List of Possible Options

405 BY – 103E Widening and Seismic Type Selection

Option 1 - RFP Design Conceptual

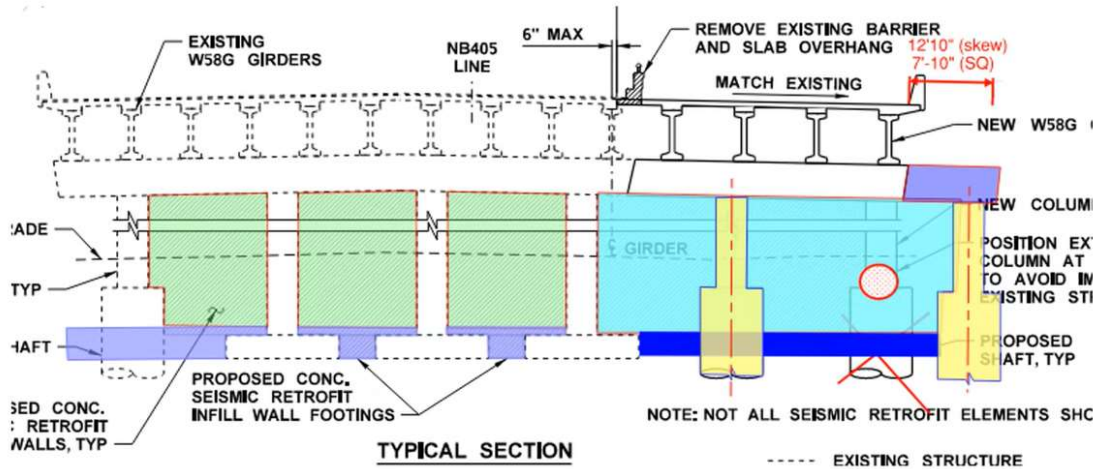
Use of casing would help mitigate risk
 Pothole to know exactly where the edge is and go in with casing
 Largest concern is where equipment is placed to do the work
 Clearzone is 10'
 10' diameter shafts

Option 2 – ATC 01 Design Conceptual

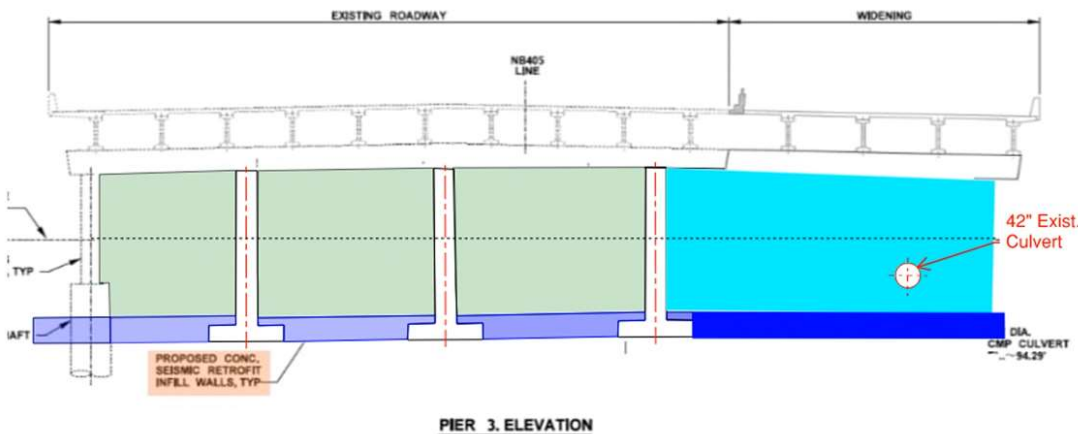
If we shrink the bridge 7.5' can we just cantilever over the culvert?

Option 3 – BD Proposed Design Conceptual

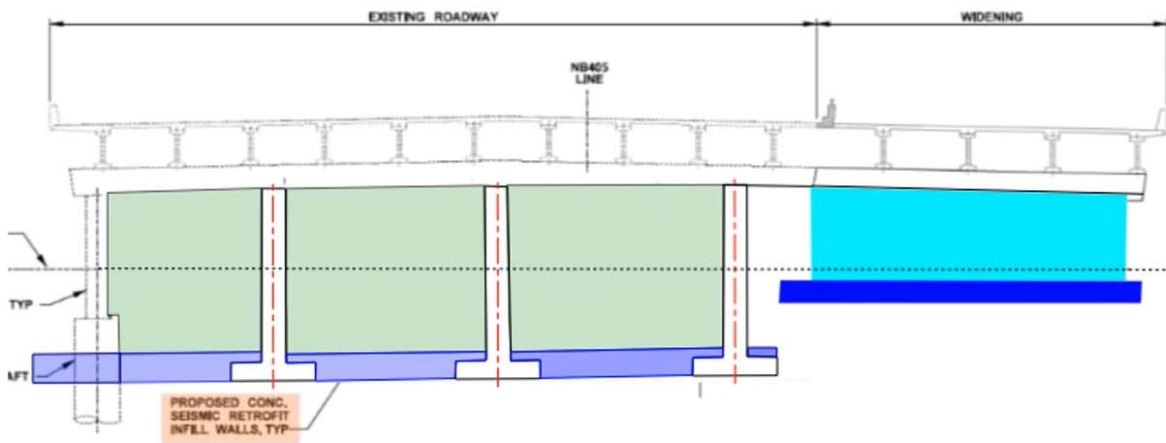
Are there other options where the pier footing is not raised?

Option 4 – Colmn Jacketing (No Infill Wall)

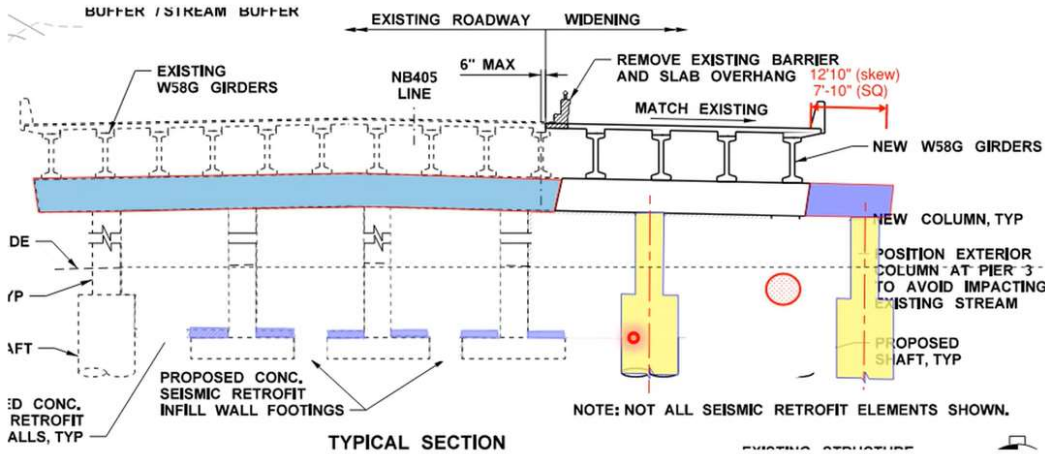
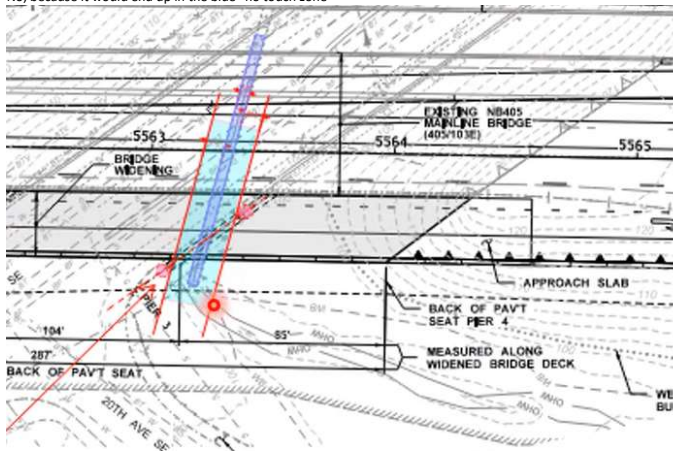
Torsion, load thru superstructure to resist the moment forces
 Hinged diaphragm on the top
 Balanced stiffness - there is flexibility from deviating
 Ductility demand - less flexibility from deviating
 Steel jacketing will provide stiffness
 FRP might not be used?
 If this got widened less, would it be possible to get that column on the other side of the culvert next to the first column?

What if the bridge gets widened in the other direction

No, because it would end up in the blue "no touch zone"

Option 5 – Weak Link

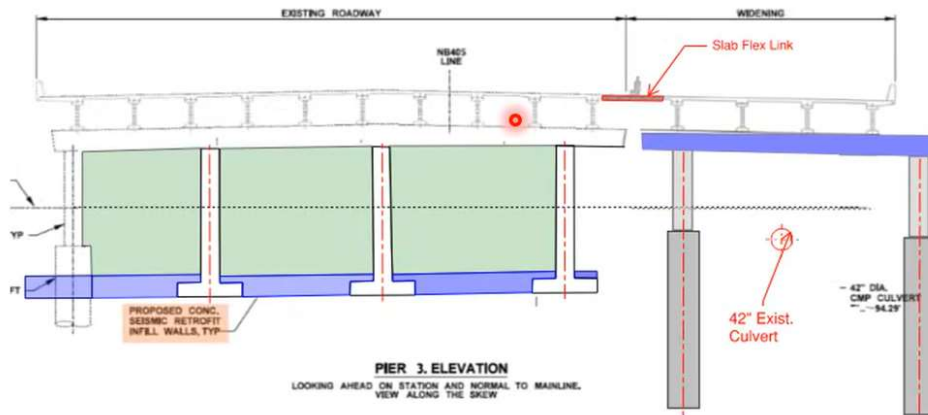
DO NOT DO THIS!!!!

Option 6 – RFP Modification 1 Raise Up Infill wall footing

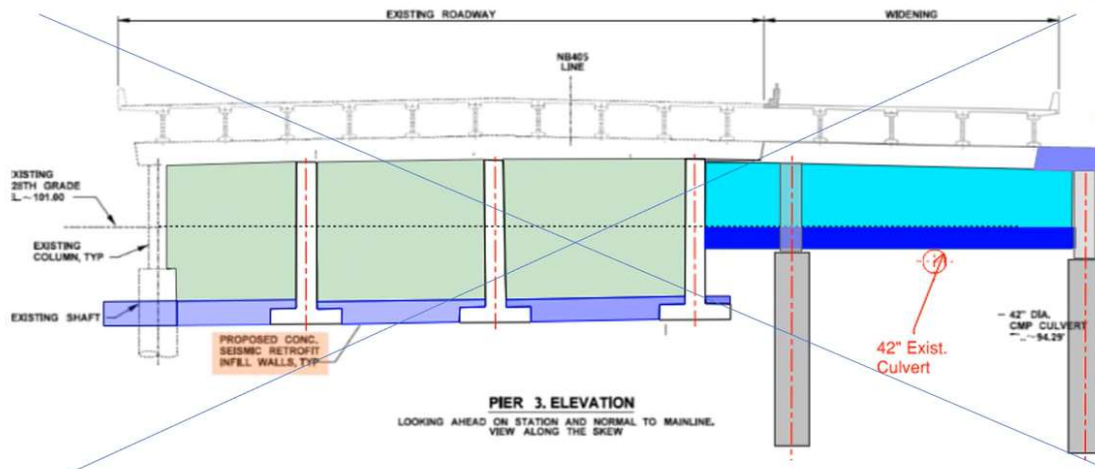
NOT DOING THIS!
Still creates a seismic pressure?
